Project	IEEE 802.16 Broadband Wireless Access Working Group < http://ieee802.org/16 >	
Title	In-band Non-transparent Relay Frame Structure	
Date Submitted	2006-03-13	
Source(s)	<p>Kanchei (Ken) Loa, Yi-Hsueh Tsai, Yung-Ting Lee, Chih-Chiang Hsieh, Shiann-Tsong Sheu, Hua-Chiang Yin, Frank C.D. Tsai, Youn-Tai Lee, Heng- Iang Hsu Institute for Information Industry 8F., No. 218, Sec. 2, Dunhua S. Rd., Taipei City, Taiwan.</p> <p>Hang Zhang, Peiying Zhu, Mo-Han Fong, Wen Tong, David Steer, Gamini Senarath, Derek Yu, Mark Naden, G.Q. Wang Nortel 3500 Carling Avenue Ottawa, Ontario K2H 8E9</p> <p>Gang Shen, Kaibin Zhang Alcatel-Lucent, Research & Innovation 388#, Ningqiao Road, Shanghai, China.</p> <p>[add co-authors here]</p>	<p>Voice: +886-2-2739-9616 loa@iii.org.tw</p> <p>Voice: +1 613 7631315 WenTong@nortel.com pyzhu@nortel.com</p> <p>Voice: 86-21-58541240-8194 gang.a.shen@alcatel-sbell.com.cn</p>

In-band Non-transparent Relay Frame Structure

Figure yyy—Example of minimum configuration for an in-band non-transparent relay frame structure

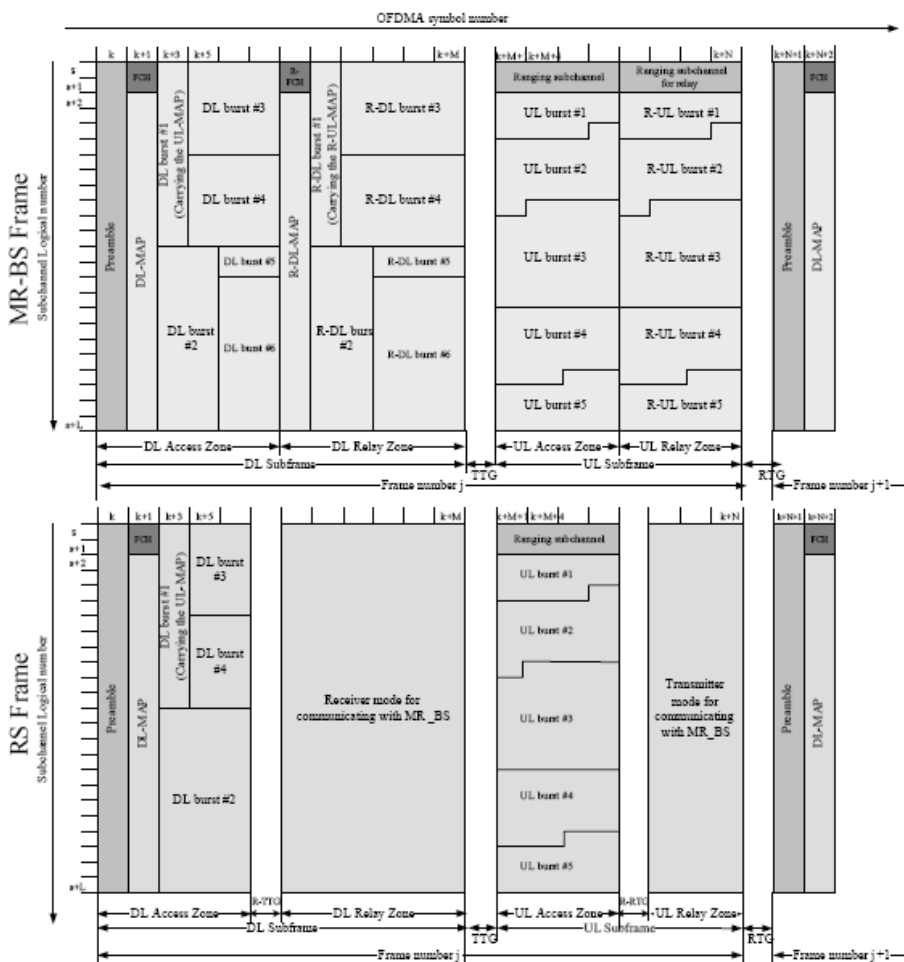
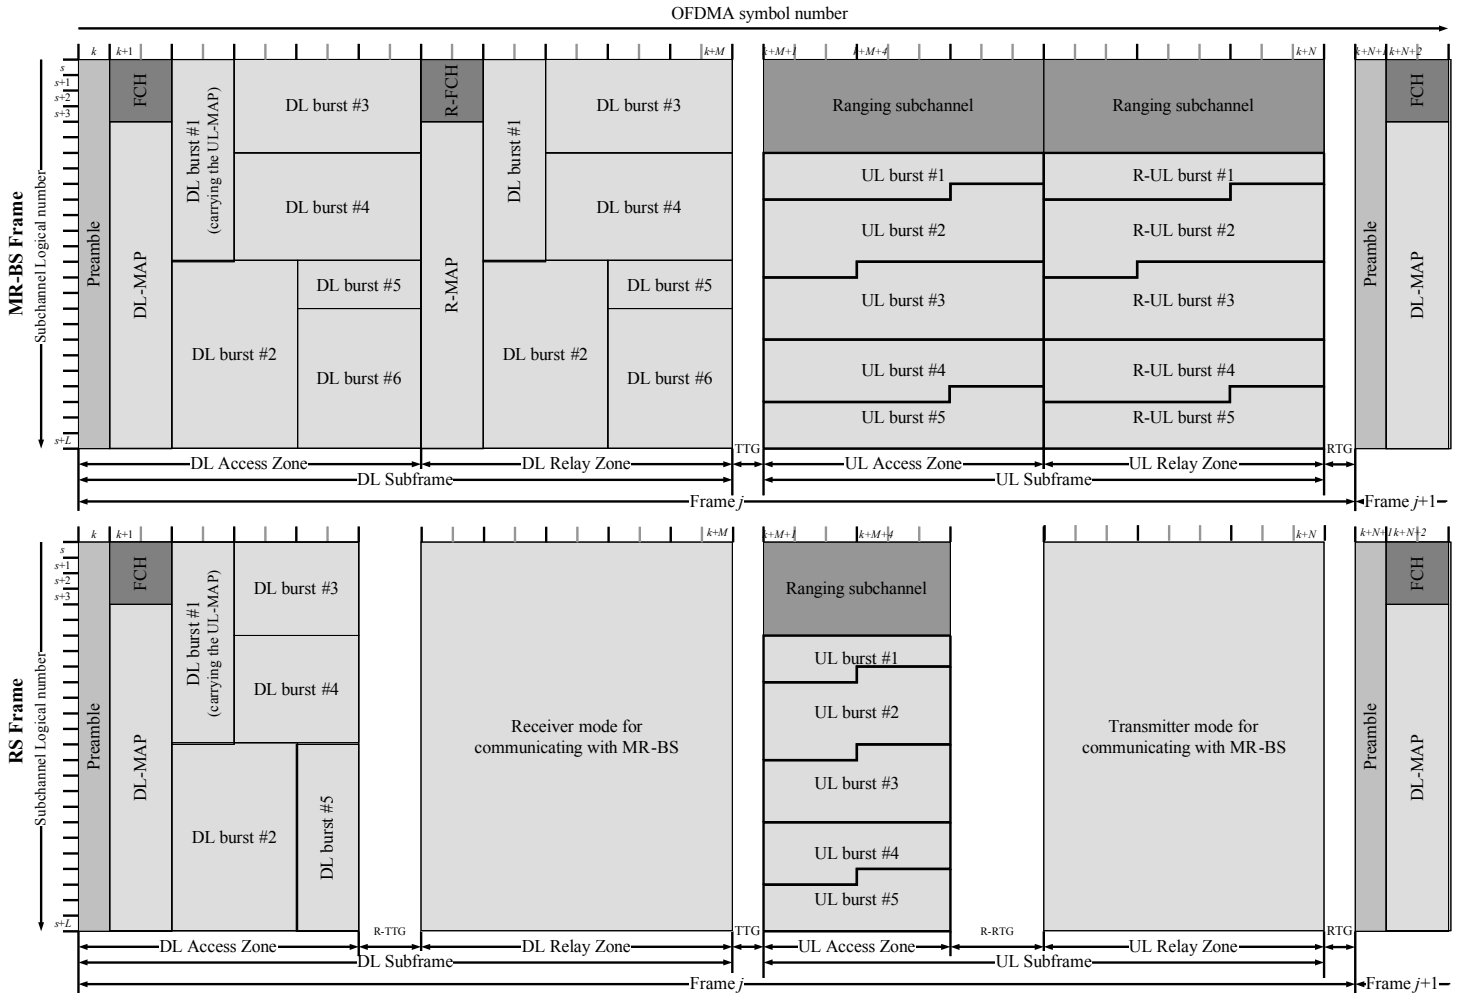
[Change the figure in section 8.4.4.7.2 “Frame structure for non-transparent mode” as indicated:]

[Replace Figure xxx with Figure yyy as follows:]
